REPORT TO APPLICATION DETERMINATION PANEL

4 Cambridge Avenue Narrabeena, 13 Rowena Road Narrabeena - Demolition works, subdivision of 2 Lots into 3 Lots (involving a boundary adjustment), construction of two (2) dwelling houses and a Secondary dwelling with associated garage and access driveways

DEVELOPMENT APPLICATION ASSESSMENT REPORT

Application Number:	DA2016/0846
Responsible Officer:	Alex Keller
Land to be developed (Address):	Lot 47 DP 25497, 4 Cambridge Avenue NARRAWEENA NSW 2099 Lot 37 DP 27573, 13 Rowena Road NARRAWEENA NSW 2099
Proposed Development:	Demolition works, subdivision of 2 Lots into 3 Lots (involving a boundary adjustment), construction of two (2) dwelling houses and a Secondary dwelling with associated garage and access driveways
Zoning:	LEP - Land zoned R2 Low Density Residential LEP - Land zoned R2 Low Density Residential
Development Permissible:	Yes
Existing Use Rights:	No
Consent Authority:	Application Determination Panel
Land and Environment Court Action:	No
Owner:	Xi Zhang
Applicant:	Vaughan Milligan Development Consulting Pty Ltd

PROPOSED SUB DIVISION and RESIDENCES
4 Cambridge Avenue NARRAWEENA NSW 2099
RESIDENCE 2 - GRANNY FLAT
ELEVATIONS SHEET 2

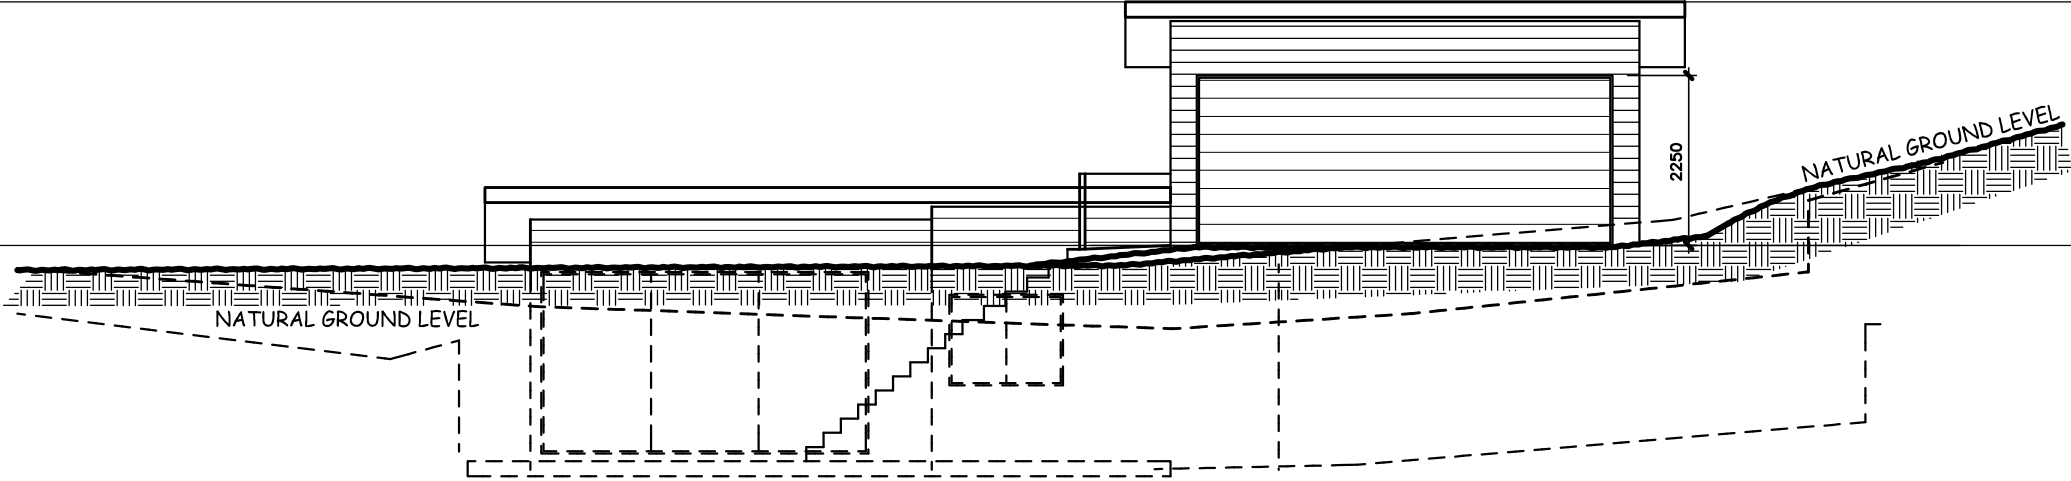
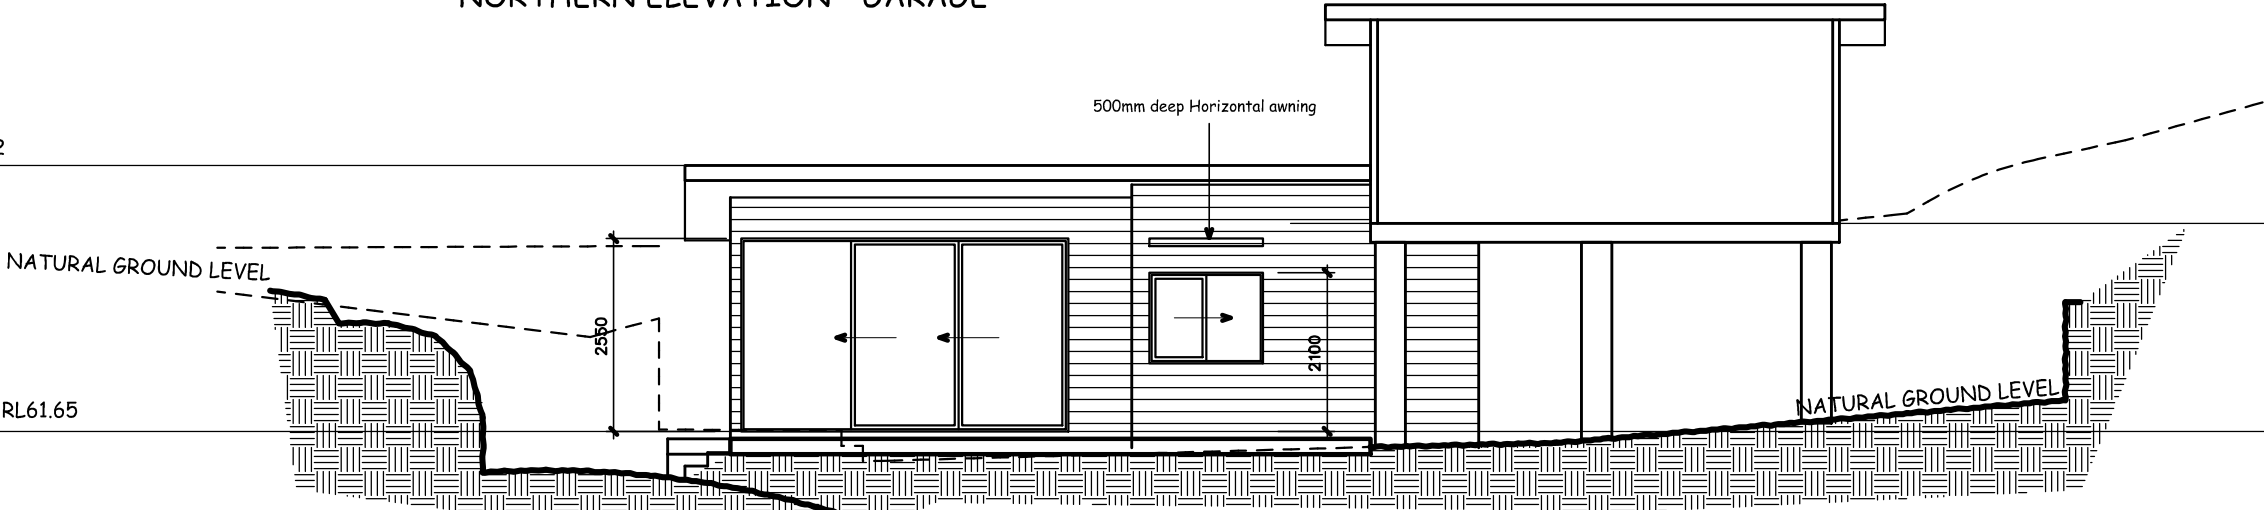
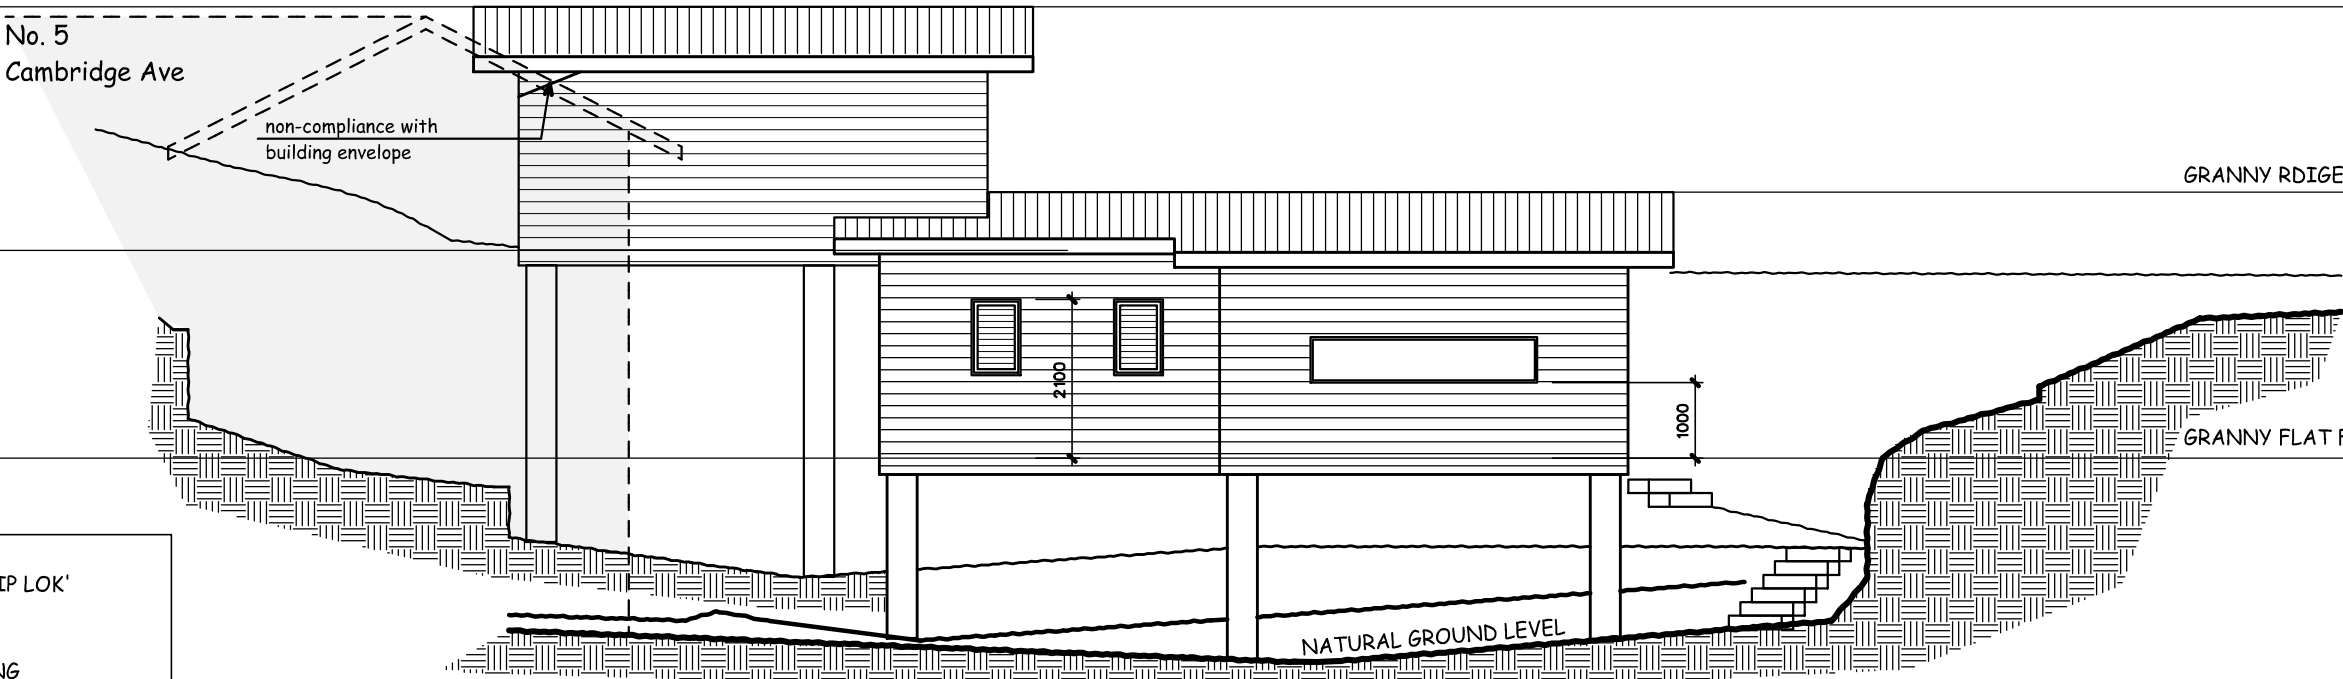
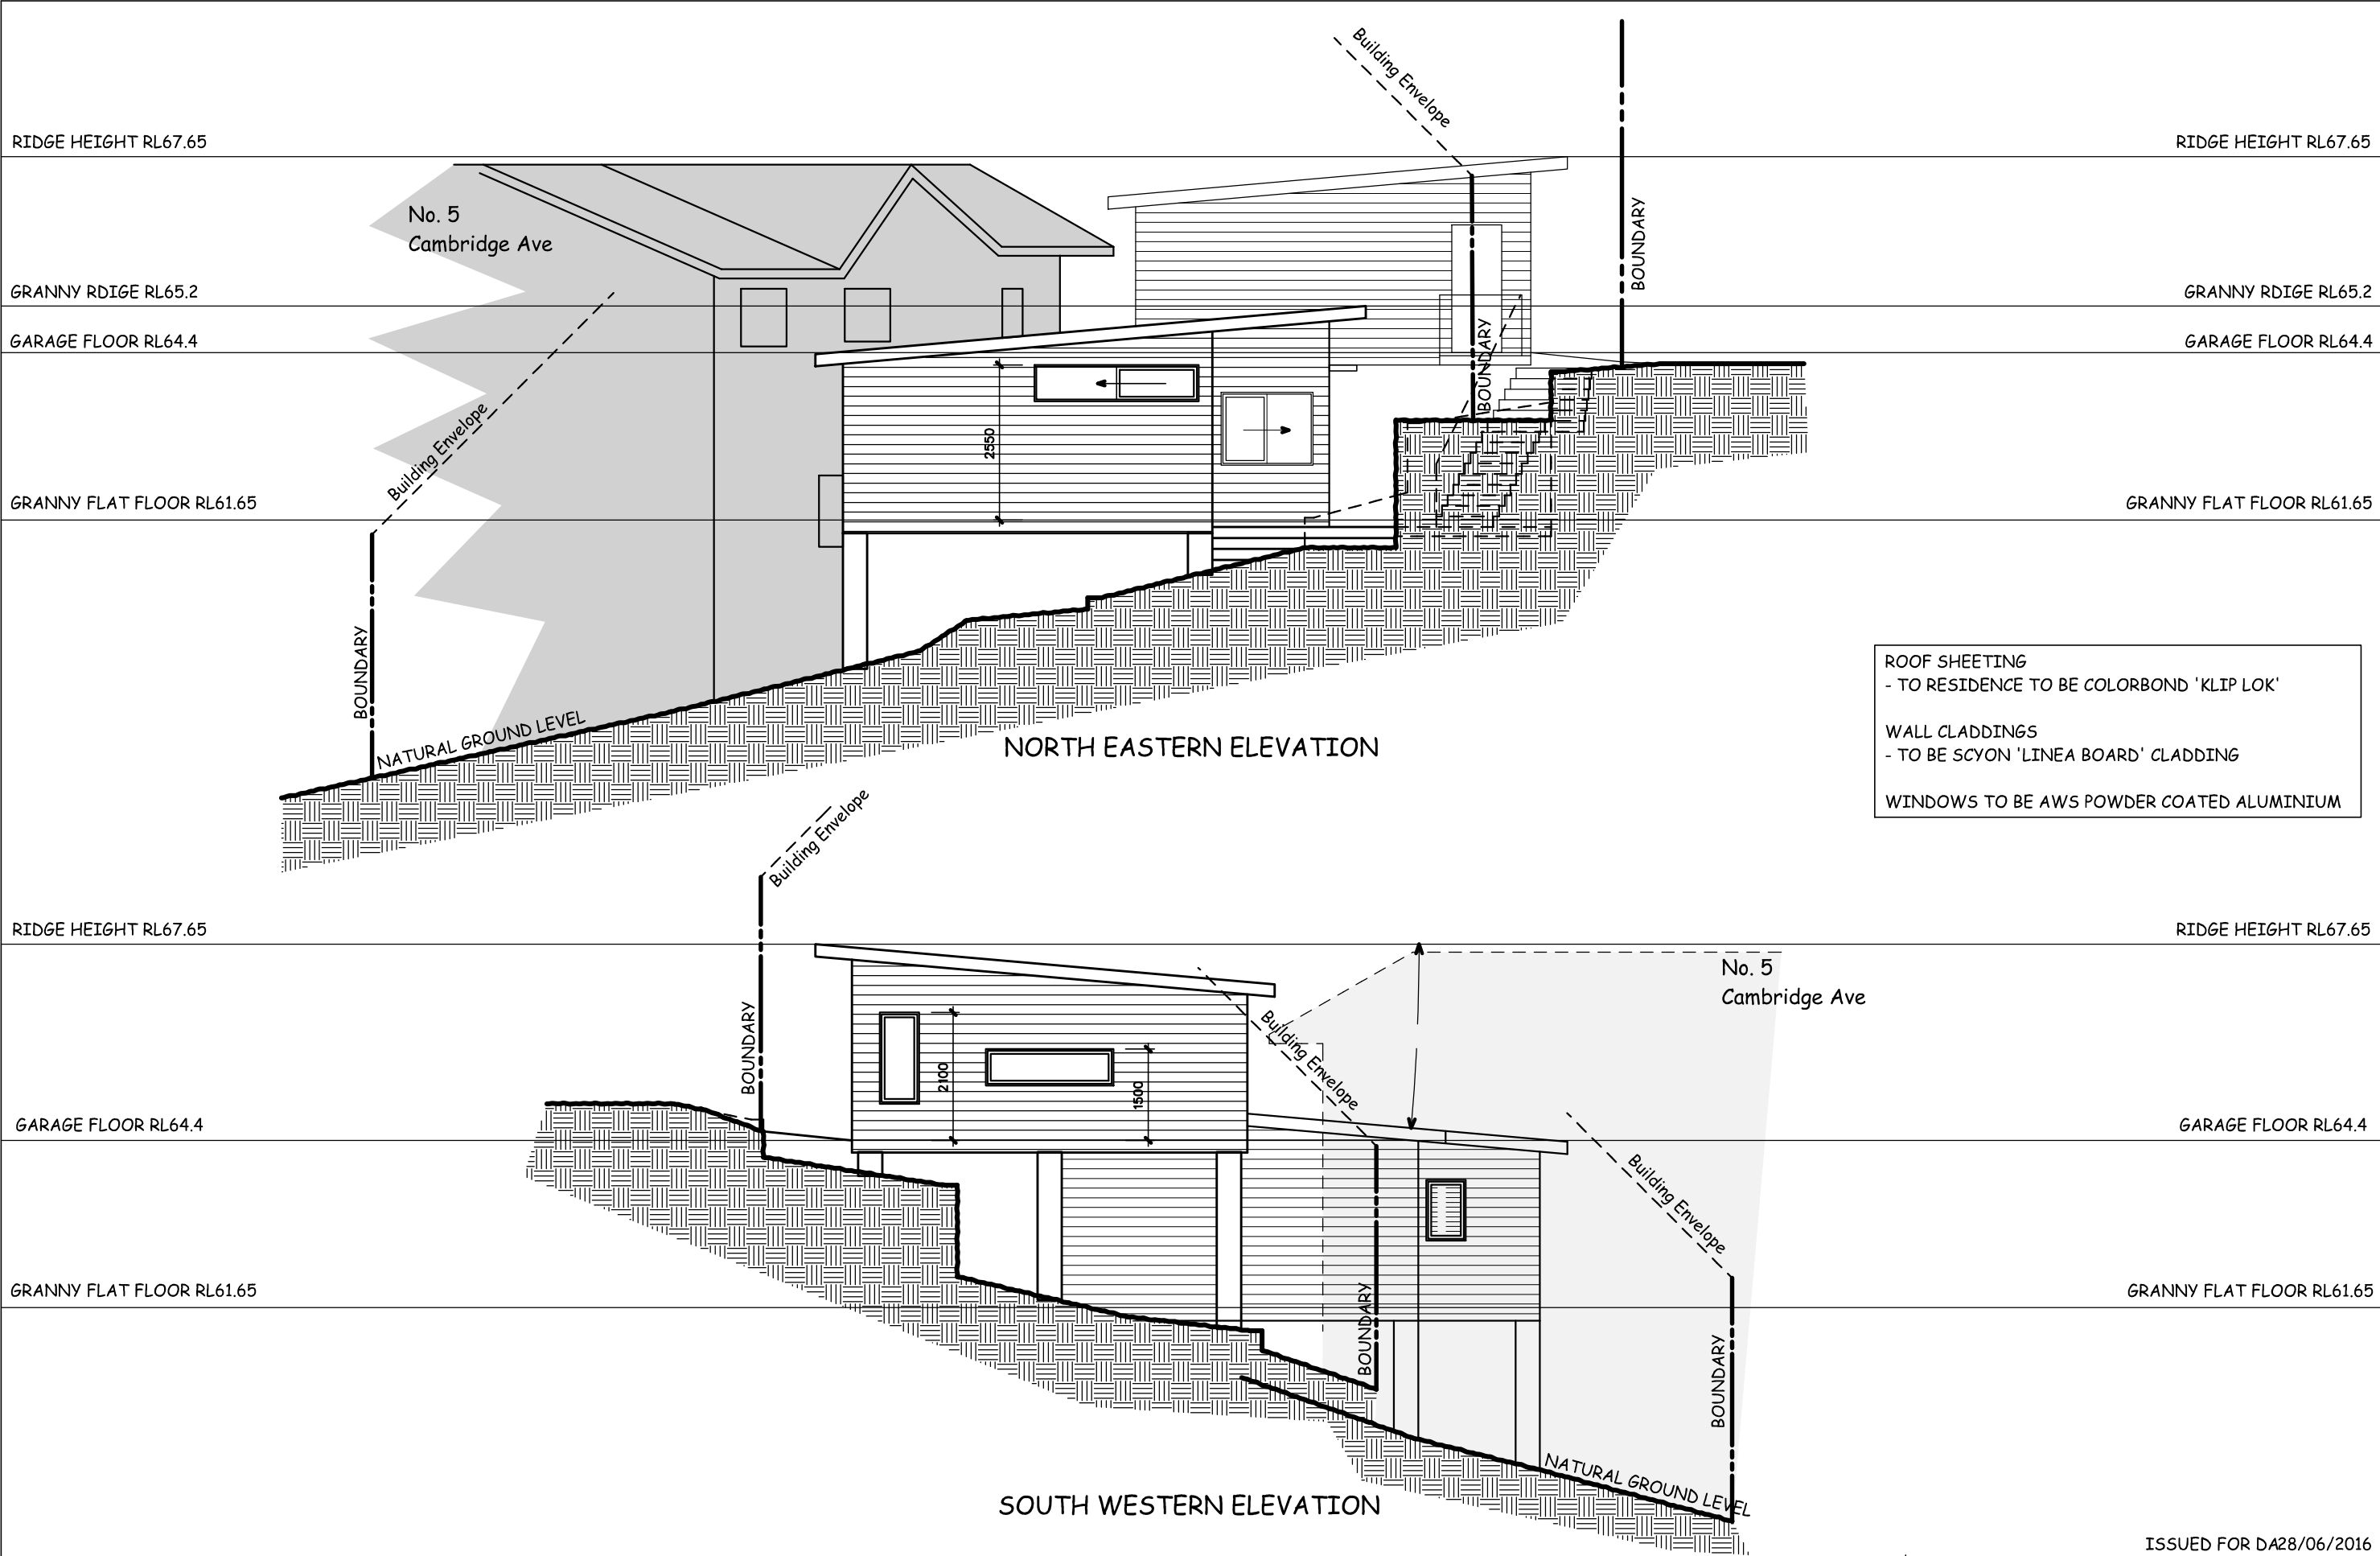
creates unacceptable overshadowing issues for adjacent land and is therefore not supported.

The proposal does not maintain reasonable access to sunlight for No.5 Cambridge Avenue by-way-of the overshadowing created by the "garage and granny flat" as well as "residence 2" shown on the plans. The plans numbered S4 to S6, dated June 2016, drawn by *Sally Gardner Design* indicate the extent of the impact on the neighbouring rear yard, leaving only limited areas away from the rear of the house with direct sunlight. The private open space that is directly accessible at the rear of No.5 Cambridge Avenue will have reduced amenity and the access to sunlight for reasonable periods on the 21 June can only be gained at the front of the house or in the more isolated areas of the rear yard, well away from the dwelling. Therefore, the proposal does not ensure reasonable access to sunlight is maintained.
